FW: jagnarine dec. FTR MSSW

Please revise FTR's inspection report and attach this document. In the interim, you can forward FTR the email informing them that the tires north of the pond are outside of the permitted solid waste and ERP permitted areas. Waste tires cannot be stored outside of the permitted areas and this becomes part of the 12-4-03 reinspection for compliance.

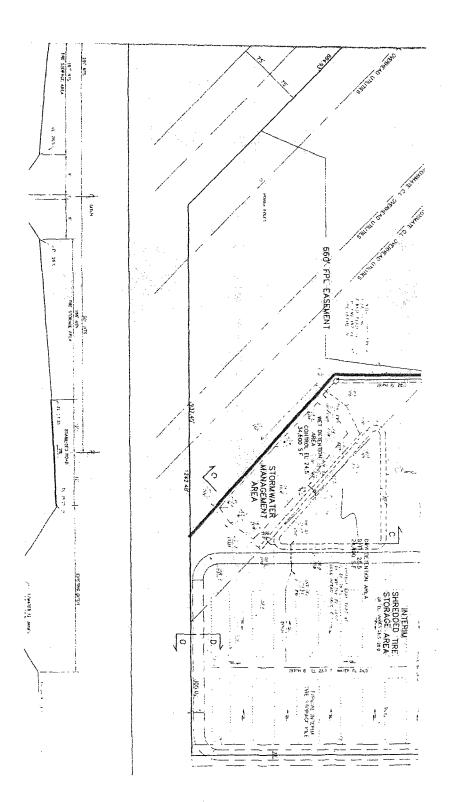
The ERP does not include the area North of the approximate red line shown in the attached.

Please let us know if the waste tires north of the pond are within the approved MSSW system. The plans we have

dated 2-29-00 show a berm at 28.0 north of the pond to Allied's property, while the approved as-builts in your files dated 12-00 show there is no berm north of the pond.
